| LINE  | QUANTITY | UOP | CAT. NO. | ITEM NUMBER | UNIT PRICE | AMOUNT |
|---|----------|-----|----------|-------------|------------|--------|
| ***** ADDENDUM NO. 6 *****  |          |     |          |             |            |        |

Addendum No. 6  
Berkeley Springs Bath House  
DNR 209090

**DEPT. of Natural Resources**  
**Additions and Alterations to**  
**Berkeley Springs Bath House**

**DNR-209090**

DWG. NO: AD-006 2 OF 14  
 PBI NO: - -  
 SHEET REF: M-1.2  
 PROJECT NO: 0408097.02

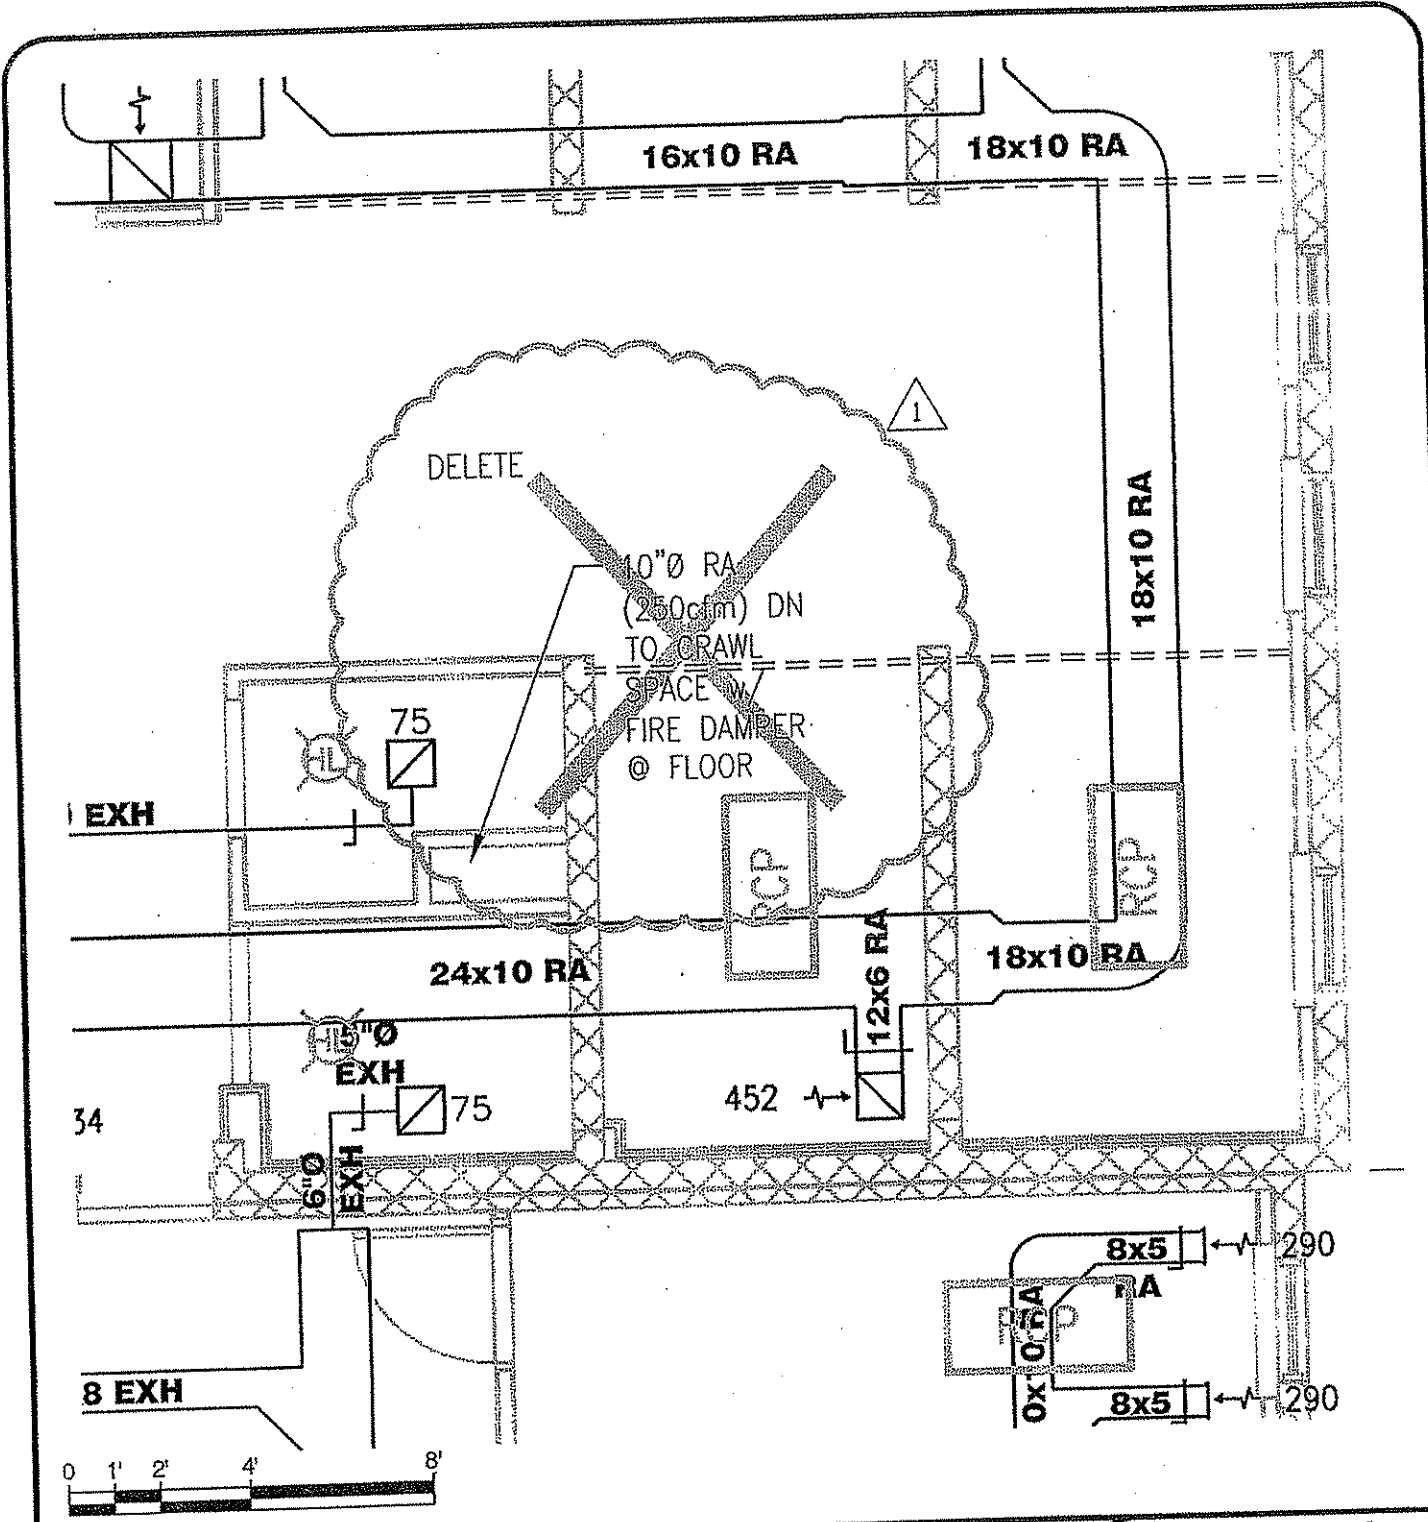
- 3.11 Sheet M-1.2  
ADD: Information about exhaust fan number EF2, See clouded area of AD-006, 2 of 14 attached.  
DELETE: Return Air Duct, See clouded area of AD-006 3 of 14 attached.  
ADD: New exhaust Ductwork, See clouded area of AD-006 4 of 14 attached.

| DATE:<br>02-25-2009  |   | SHEET REF:<br>M-12         |

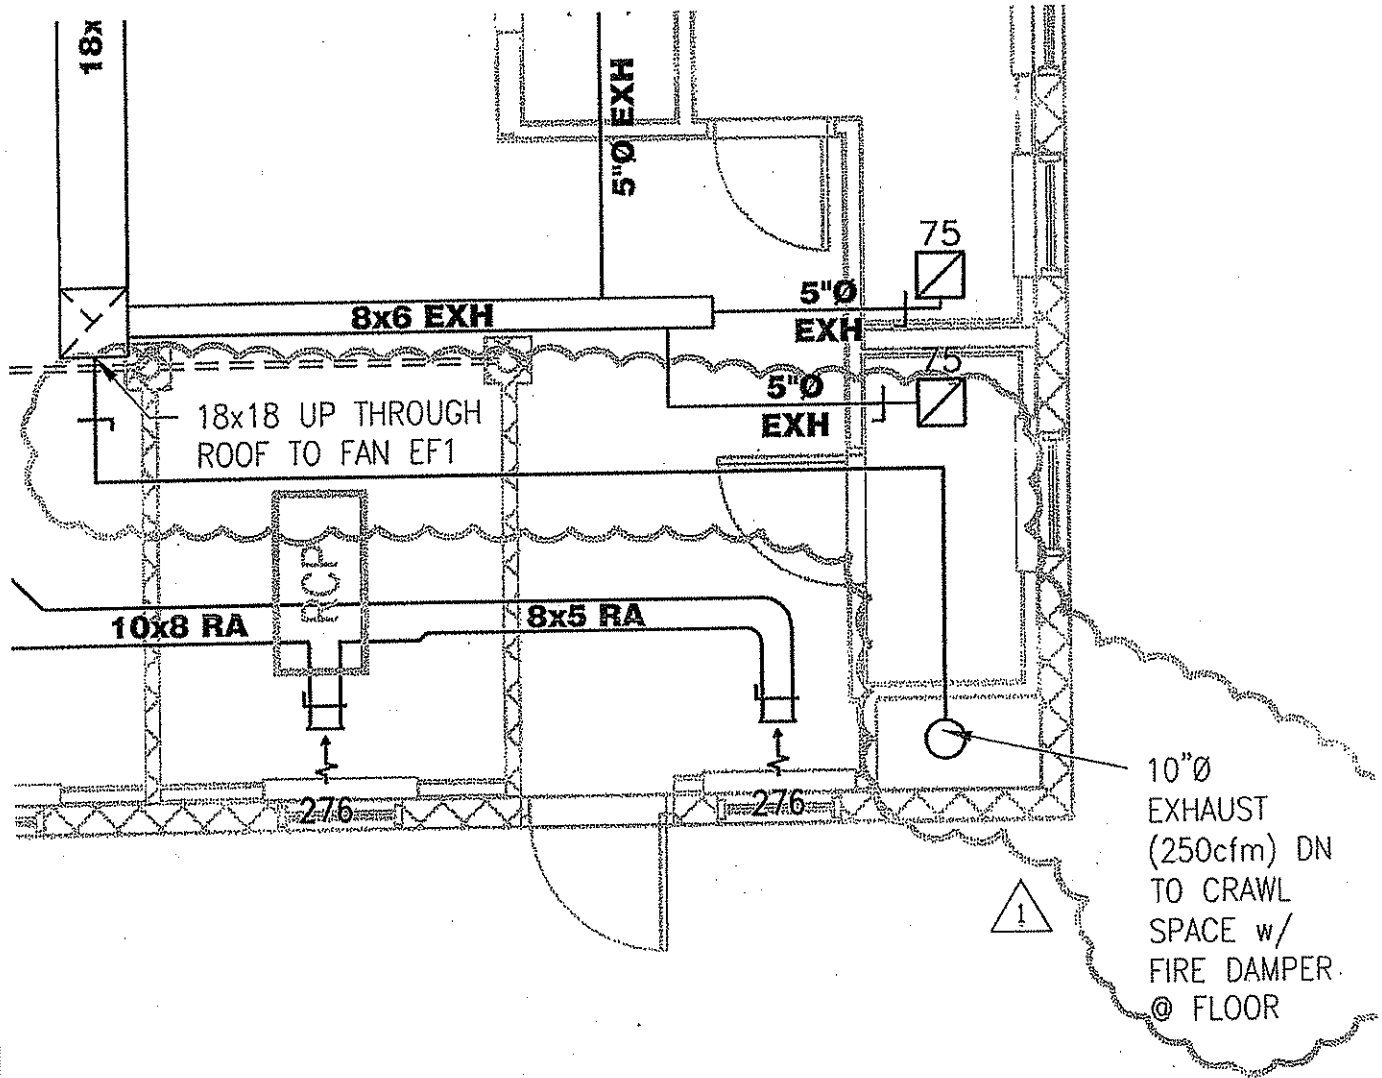
- A: Fire dampers are called for on one supply run (Sheet M1.1) and one exhaust run. Sheet M1.2; see addendum drawing AD-006.
- 4.24 Q: Drawing M1.1, note 14 calls for the installation of an LP tank and associated piping. Drawing PME-1.1 indicates the tank is existing. Please clarify.

| DATE:<br>02-25-2009  |  | SHEET REF:<br>M-1.3        |

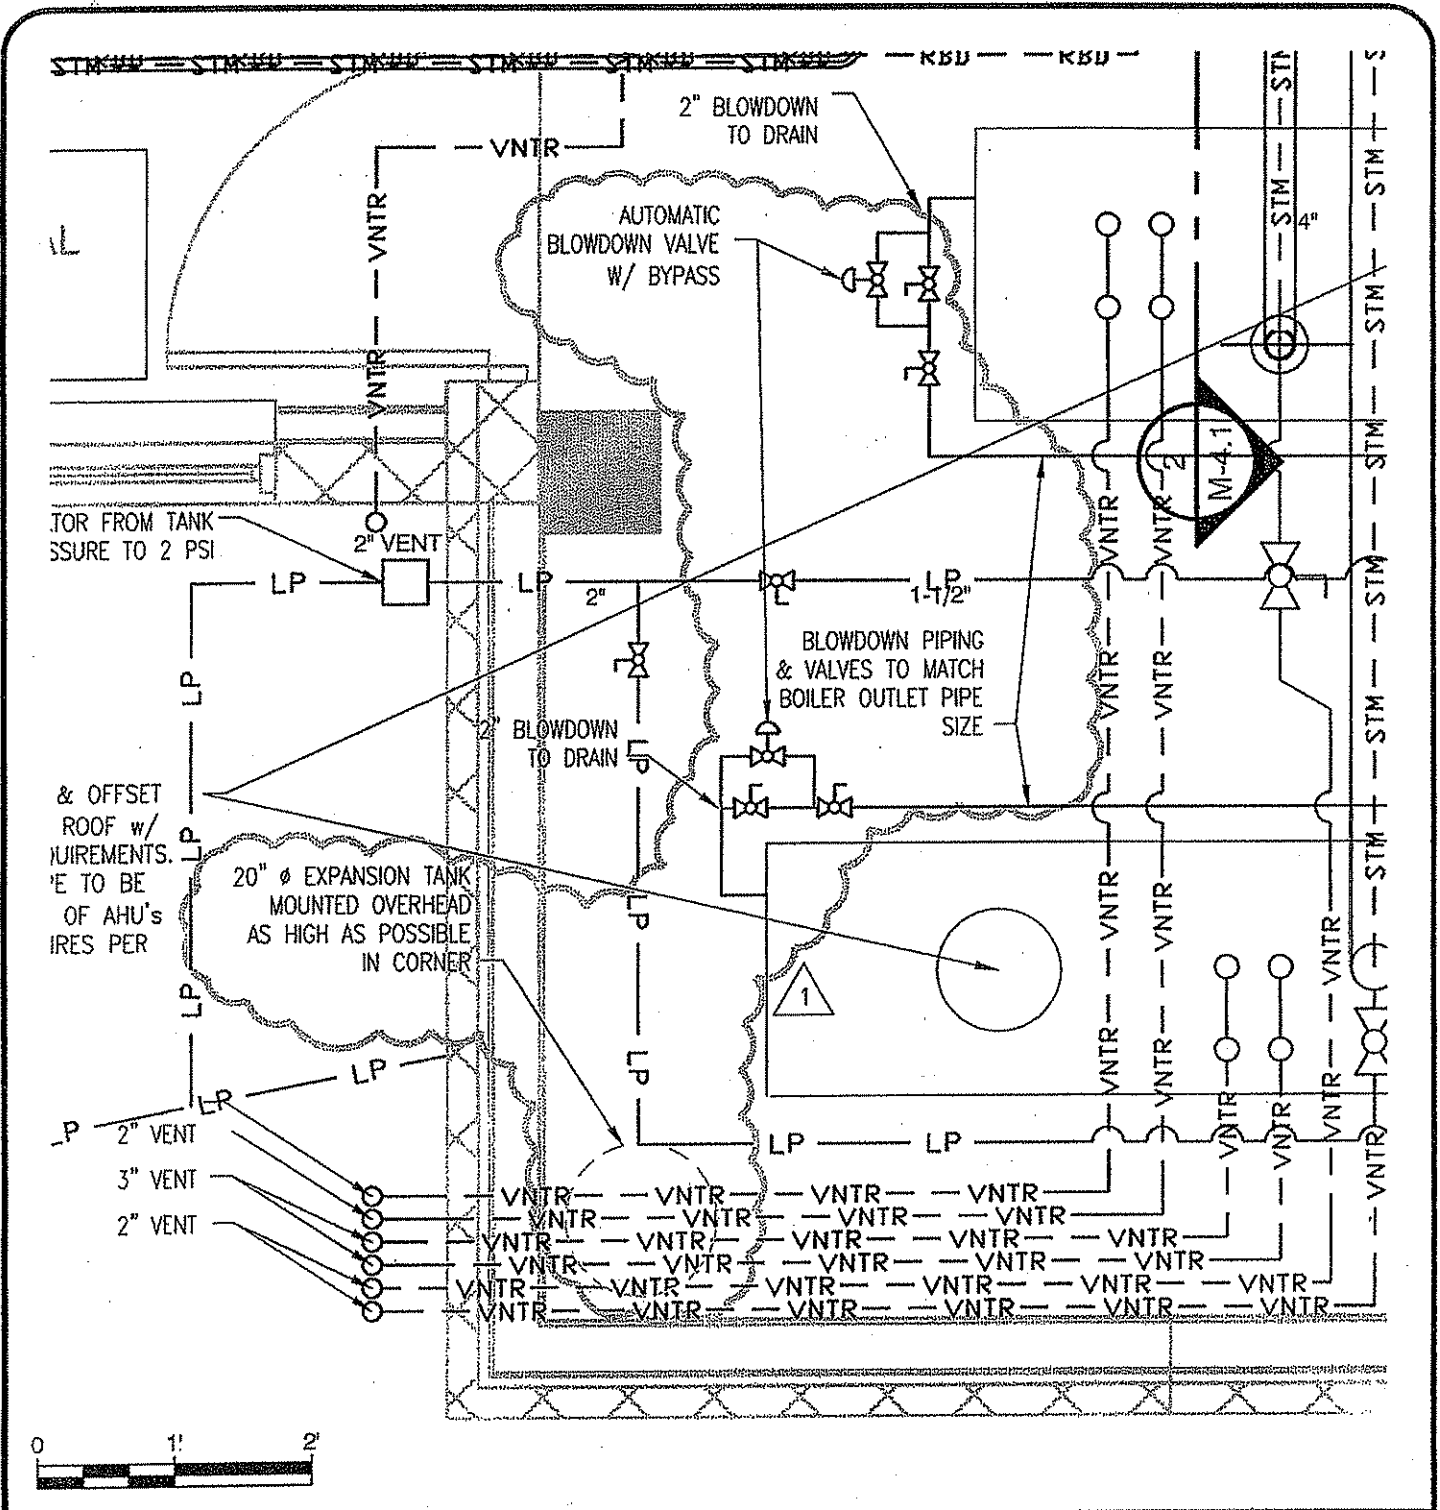
- 3.12 Sheet M-1.3  
REVISE: Hot and Chilled Water Piping, See clouded area of AD-006 5 of 14 attached.
- 3.13 Sheet M-4.1  
CLARIFICATION: Boiler Control Manufacturers, See clouded area of AD-006 6 of 14 attached.  
CLARIFICATION: Boiler Control Manufacturers, See clouded area of AD-006 7 of 14 attached.

- 4.13 Q: In talking with the maintenance man while on the jobsite, he is saying where the chilled pipe enters the crawlspace, on the SW end of the building, the piping will be located over the under floor reservoir and he has concerns about running the pipe over this because of the glycol in the system, in case there would be a leak. Would it be possible to run the chilled piping up the side of the building and onto the roof, where the units are going to set, and do away with any chilled pipe located in the crawl space completely?  
A: See addendum drawing AD-006 5 of 14 and AD-009 for revised routing of CW piping entry.

| REV. BY:<br>MEI  | DWG. DESCRIPTION:<br>ROOF EXHAUST FAN DETAIL<br>CLARIFICATION | DWG. NO:<br>AD-006 8 OF 14 |

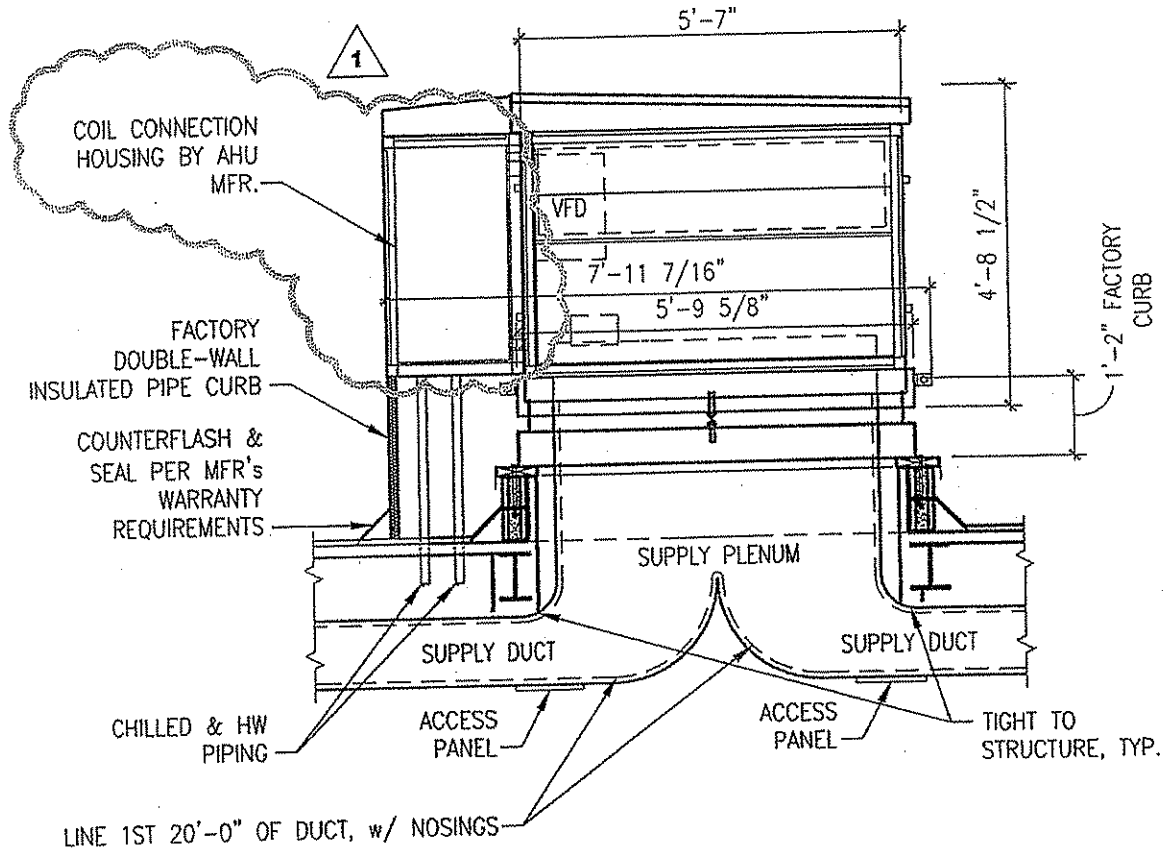
- 3.14 Sheet M-5.1  
Detail 10  
CLARIFICATION: Roof Exhaust Fan, See clouded area of AD-006 8 of 14 attached.  
Detail 7  
CLARIFICATION: End elevation view of AHU-1 & AHU-2, See clouded area of AD-006 9 of 14 attached.  
Detail 8  
CLARIFICATION: Air Handling Unit, See clouded area of AD-006 10 of 14 attached.  
Detail 9  
CLARIFICATION: Air Handling Unit, See clouded area of AD-006 11 of 14 attached.

| REV. BY:<br>MEI  | DWG. DESCRIPTION:<br>ELECTRICAL PANEL<br>REVISIONS | DWG. NO:<br>AD-007 1 OF 3 |

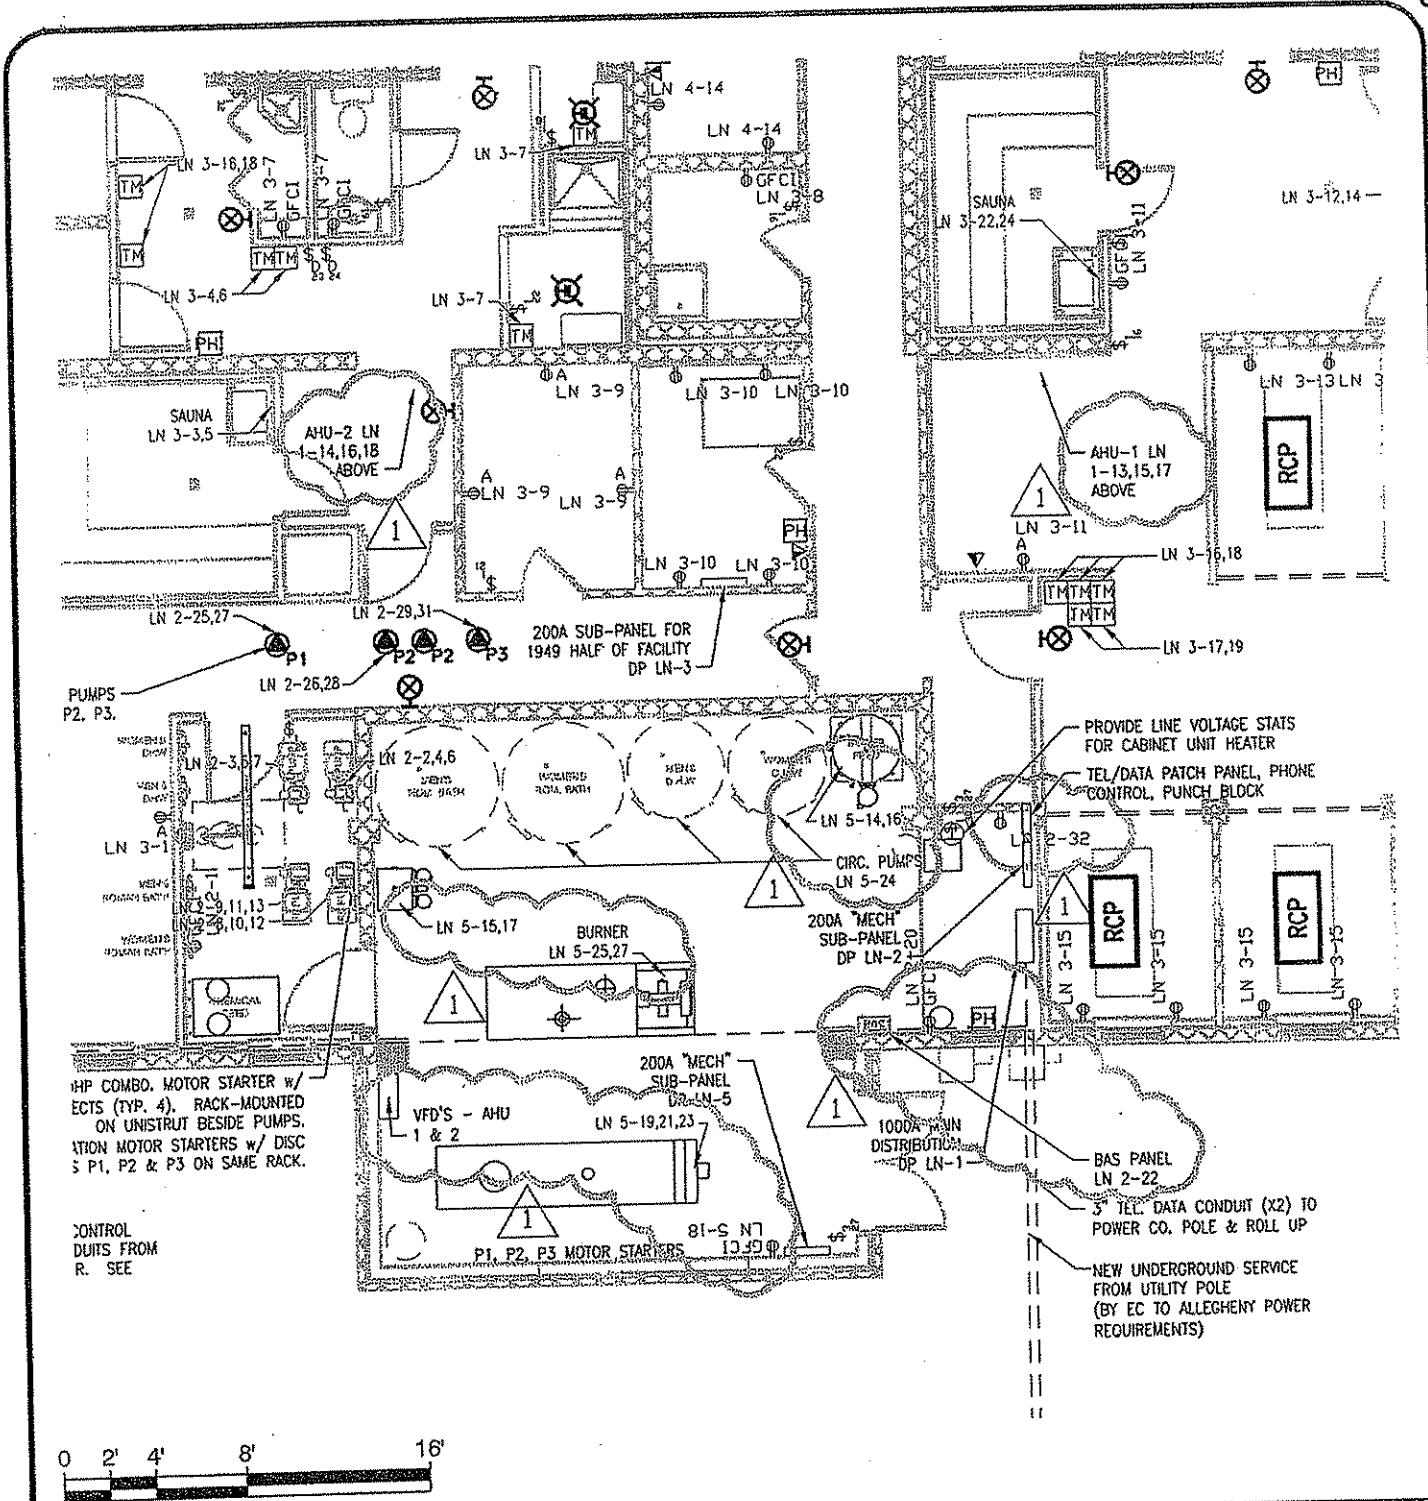
- 3.18 Sheet E-1.1  
REVISE: Electrical Panel Revisions, See clouded area of attached AD-007 1 of 3.  
ADD the following as Note #32: "Final coordination of scope of work, dimensions, fixture placement, routings, etc is the responsibility of the GC and all sub contractors prior to bidding. Verify all field conditions and measurements prior to bidding. Coordinate all work with other trades. Coordinate all mounted devices with all other trades prior to installation. Firestop all penetrations of fire walls (see arch plans) and floors."
- 3.19 Sheet E-5.1, Electrical Details  
ADD: Vaporizer System Detail, See AD-011 attached.
- 3.20 Sheet E-6.1  
MODIFY: Breaker 32 description, See attached AD-007 2 of 3 attached.
- 3.21 Sheet E-6.2  
MODIFY: Breakers 26 & 28, See clouded area of AD-007 3 of 3 attached.
